Re: Turkey Point Units 3 and 4
Docket Nos. 50-250 and 50-251
Revised ECCS Analysis

REVISED ECCS ANALYSIS
TURKEY POINT UNITS 3 & 4

SUBJECT: TURKEY POINT UNITS 3 & 4
PROPOSED TECH SPEC CHANGE
ECCS REANALYSIS (19% S/G PLUGGING)

Figure 2.1-1a Reactor Core Thermal and Hydraulic Safety Limits, Three Loop Operation

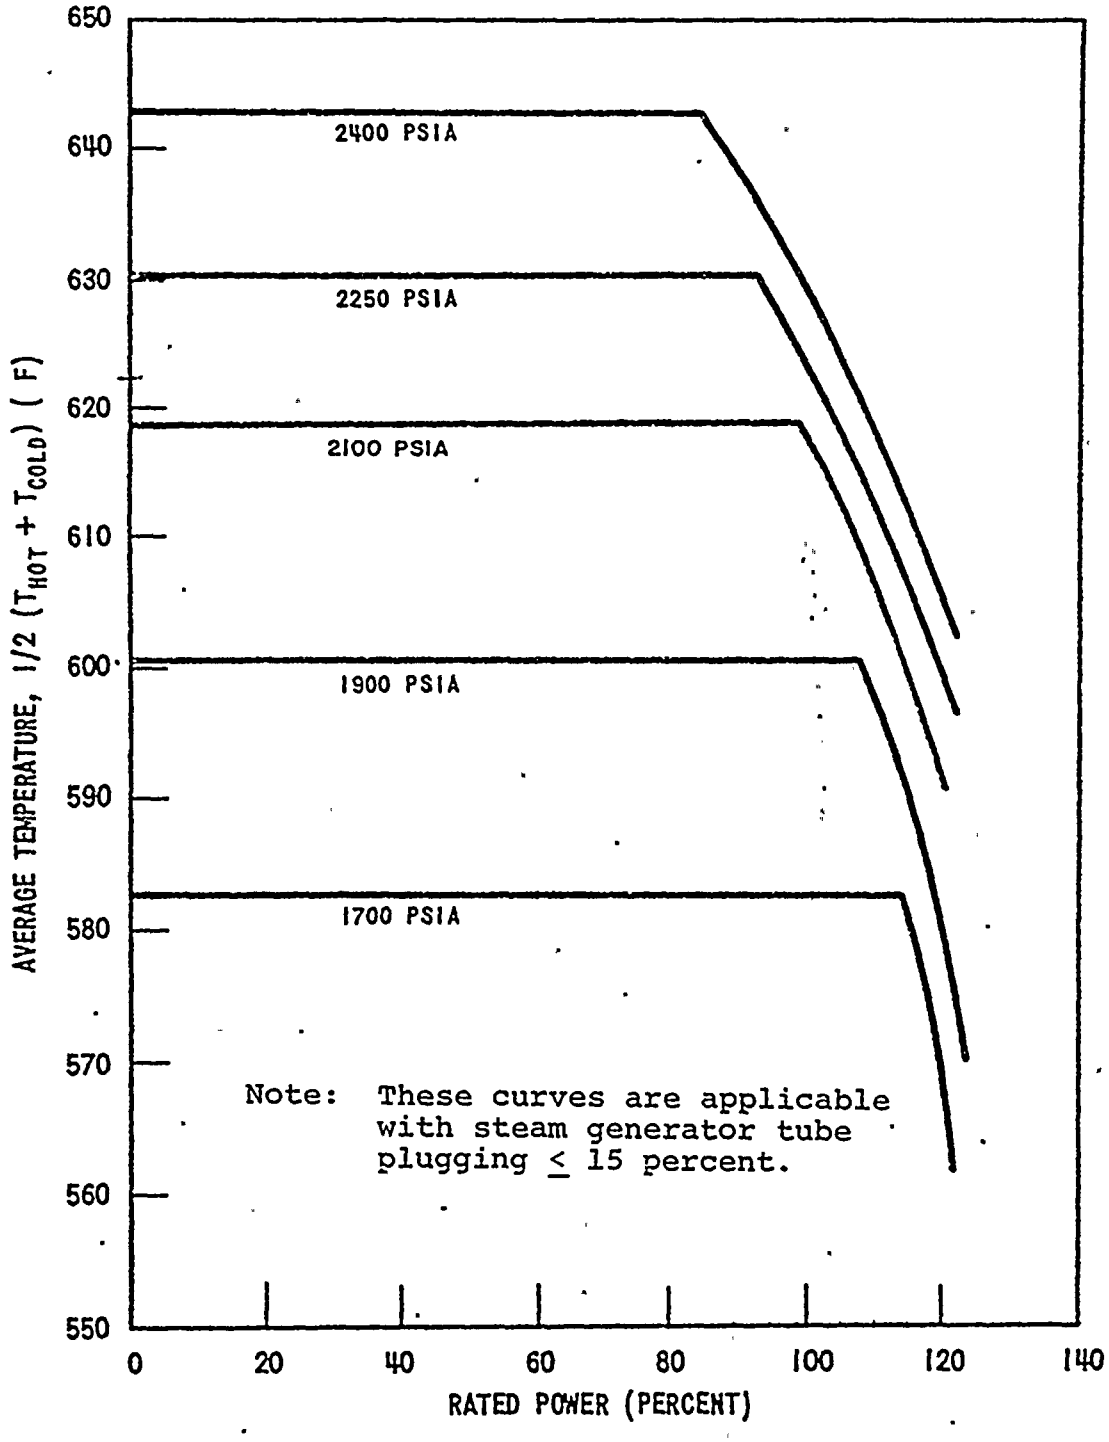
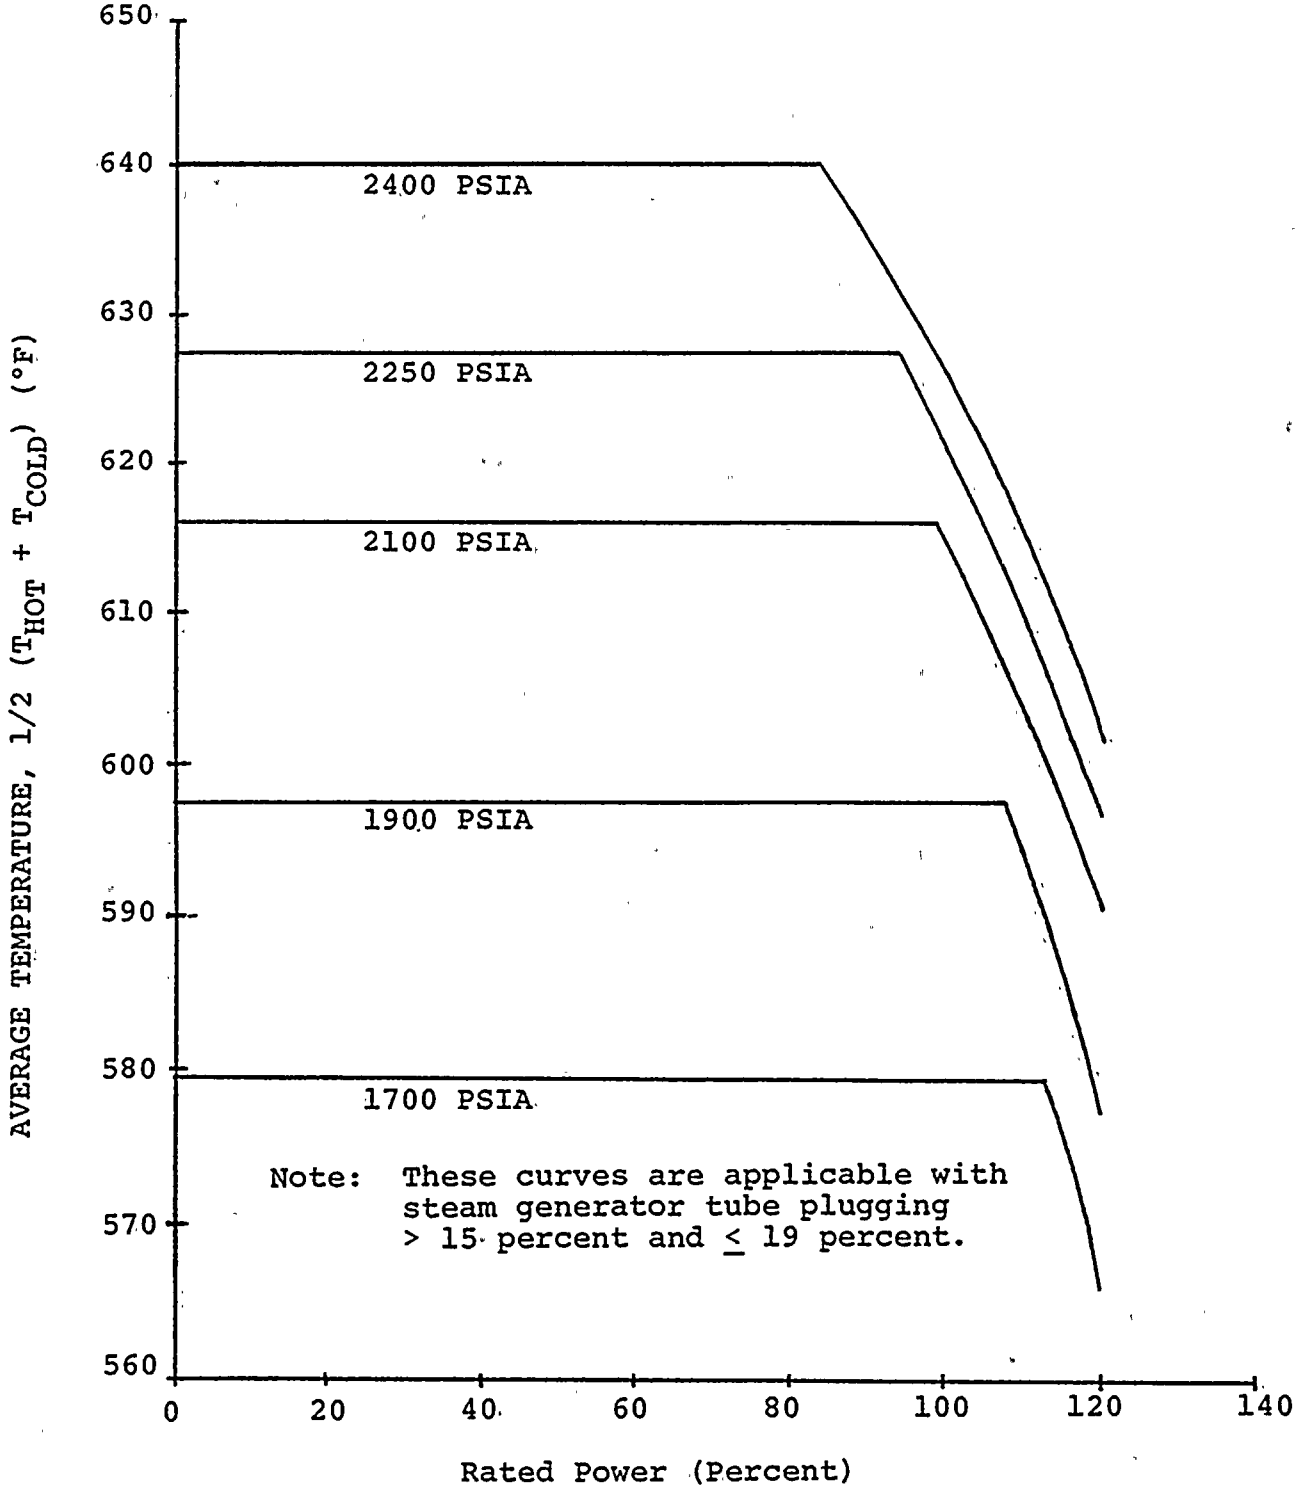
This evaluation supports several changes to the Technical Specifications which have been brought about by the potential plugging of additional steam generator tubes at Turkey Point Units 3 and 4. Technical Specification 3.1.6.c (Reactor Coolant Flow) and 3.2.6.a (Hot Channel Factors), the Over-temperature ΔT and Overpower ΔT equations, and Figure 2.1-1 (Reactor Core Thermal and Hydraulic Safety Limits, Three Loop Operation) will be affected.

*K_1 = 1.095 for steam generator tube plugging $\leq$ 15 percent ,

K_1 = 1.08 for steam generator tube plugging > 15 percent and $\leq$ 19 percent

Variation in Reactivity Insertion Rate with Initial Boron Concentration for a Boron Dilution Rate of 230 GPM
Reactivity Insertion Rate, δk/sec x 10^5
2.0
1.0
0
0
1000
2000
2500
Initial Boron Concentration, PPM

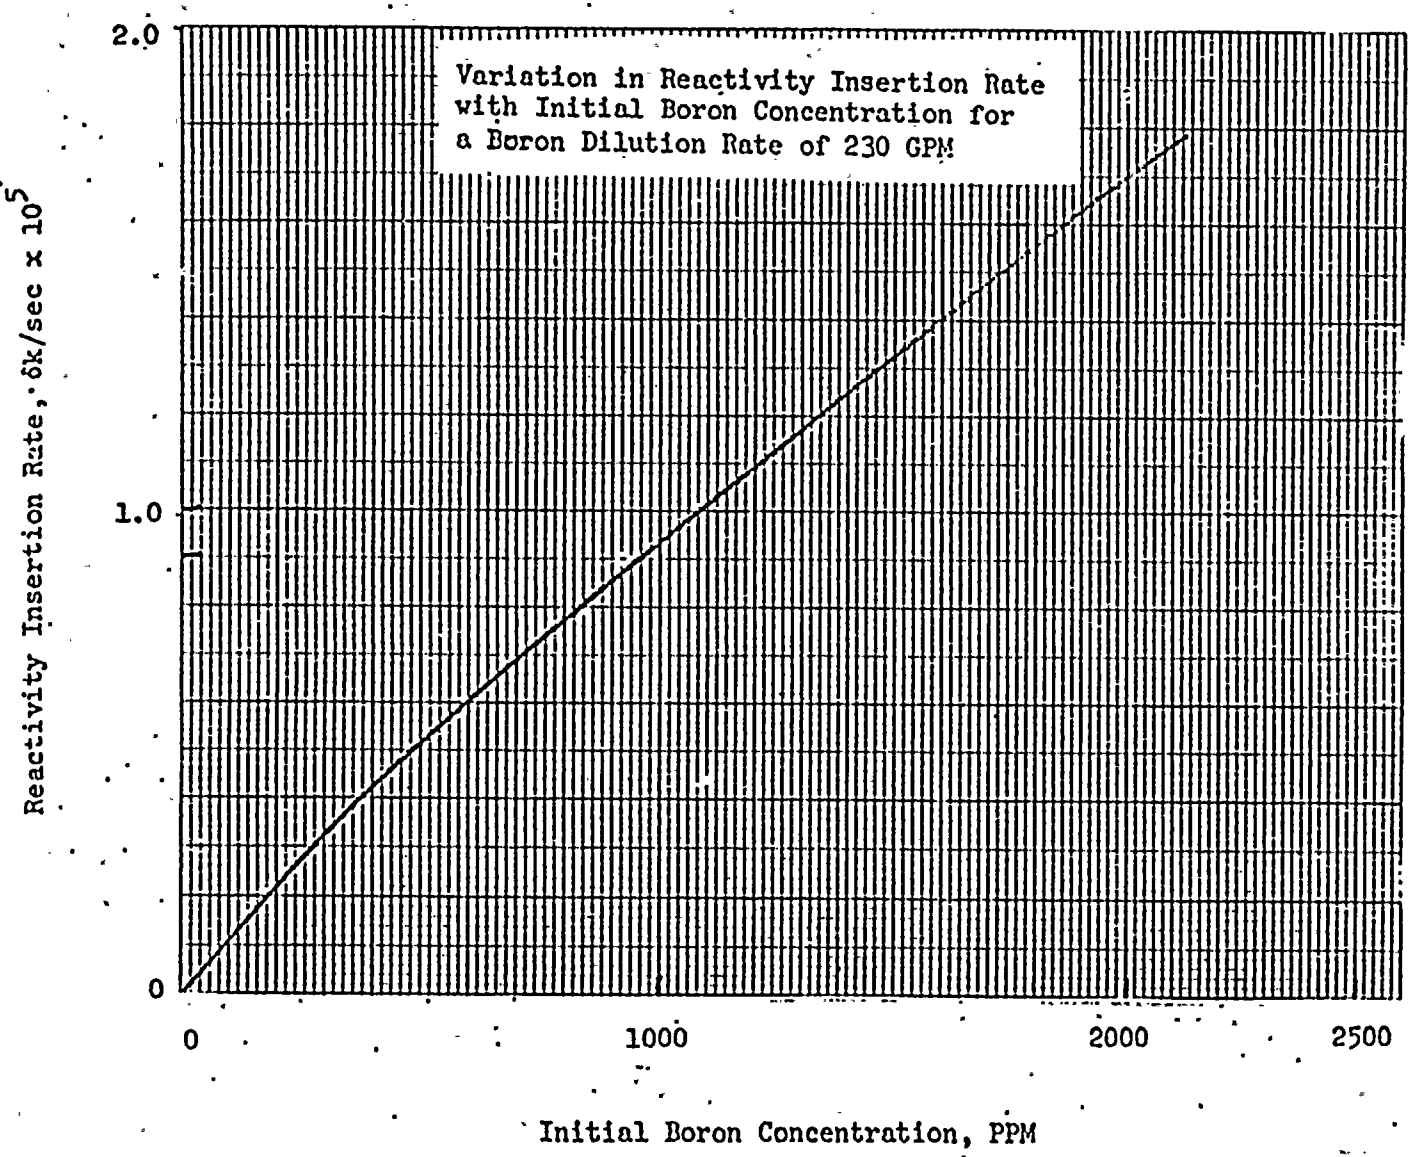
For dilutions during power operation a highly conservative reactivity insertion rate of 1.1×10^{-5} δ k/sec was assumed in the FSAR consistent with an initial boron concentration of 1200 ppm. FSAR figure 14.1.5-1 (Reactivity Insertion Rate vs Boron Concentration) has been recalculated consistent with the lower primary value and is attached. The results show that the reactivity insertion rate assumed in the FSAR is still conservative. Therefore no additional analysis is required. It should be noted, however, that the FSAR analysis is still highly conservative with respect to the current cycles since the analysis assumed that only 1% shutdown margin is available. The Turkey Point Units have been designed such that > 2.5% shutdown margin is always available for BOL conditions. The result is that operator action times would be > 70 minutes with the more realistic value.
